Constellation  
Heritage  
> 4700 Models

Western Star  
Service Bulletin

**Fig. 1, ConMet PreSet Drive Hub, Cut-Away View**

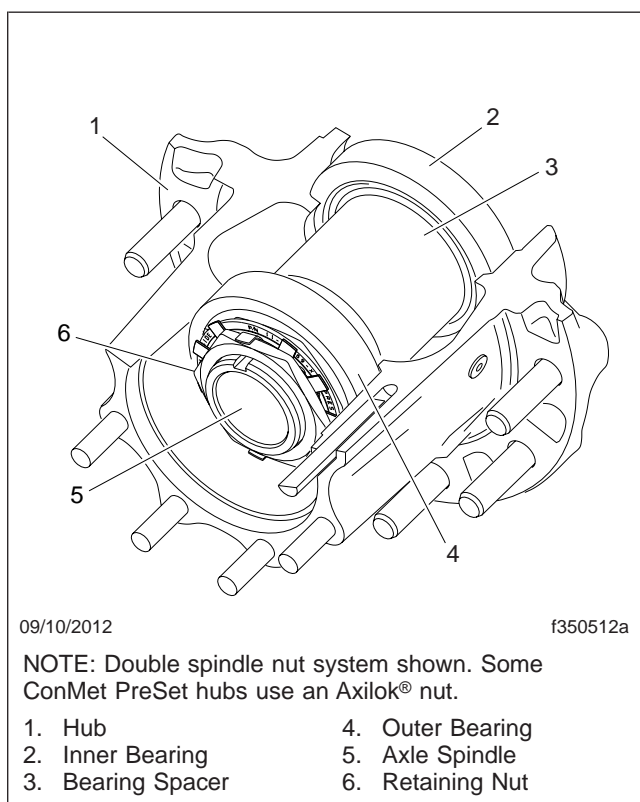
For vehicles equipped with ConMet PreSet® hubs, ConMet recommends replacing the bearing spacer with a new one whenever a hub is removed. See **Fig. 1**. Bearing spacers are available through PartsPro®.

**Fig. 2, PreSet and PreSet Plus Bearing Spacers**

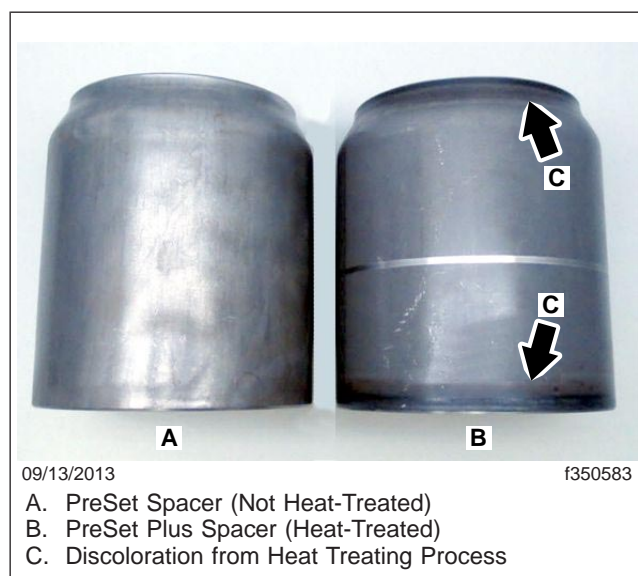
To distinguish between a PreSet and PreSet Plus™ bearing spacer, check the ends of the spacer. PreSet Plus bearing spacers have undergone a heat-treating process that discolors the ends; see **Fig. 2**. This type of discoloration is normal for heat-treated spacers. PreSet bearing spacers have not been heat-treated.
